Your ref  
APP/21/00747

Our ref  
PLAN-041873

**Proposal:** Single storey rear extension.

**Site:** APP/21/00747: - Northlands Cottage, 16 New Brighton Road, Emsworth, PO10 7PS.

Southern Water MapGuide Browser

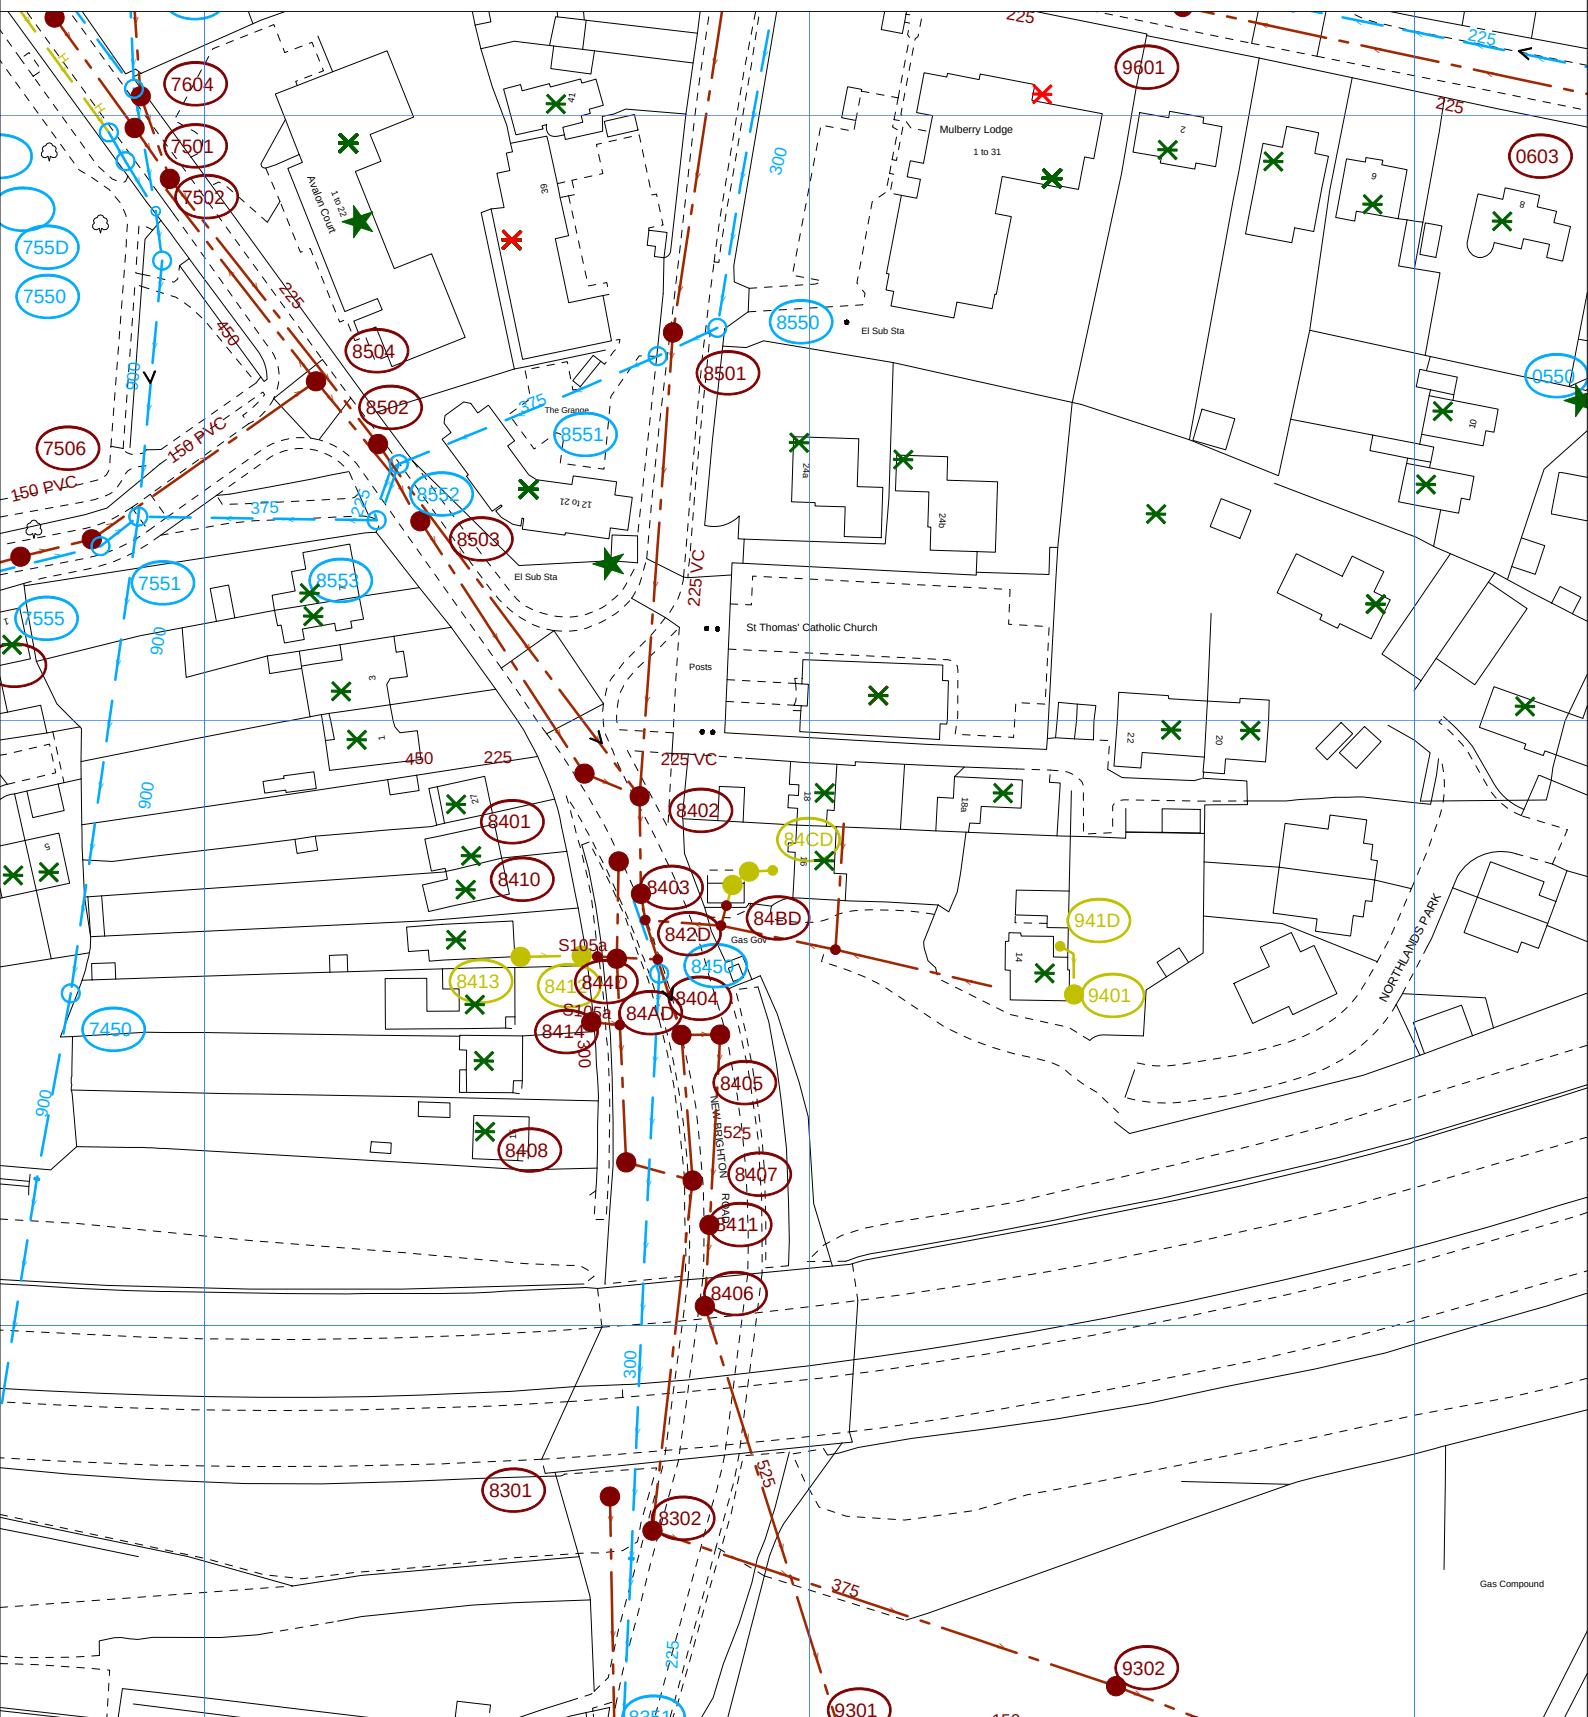
It appears that the developer is intending to build close-to a public surface water sewer which is crossing the site. Building over a “public sewer” is not normally permitted by Southern Water. An investigation of the sewer is required to confirm its size and depth, ascertain its condition, number of properties served and potential means of access before any decision can be made as to whether it would be acceptable for Southern Water to allow building- close-to the sewer.

Furthermore, it is possible that a sewer now deemed to be public could be crossing the development site. Therefore, should any sewer be found during construction works, an investigation of the sewer will be required to ascertain its ownership before any further works commence on site.

In order to protect drainage apparatus, Southern Water requests that if consent is granted, the following condition is attached to the planning permission; Prior to the commencement of development, the developer must advise the local authority, in consultation with Southern Water, of measures which will be undertaken to protect the public sewers.
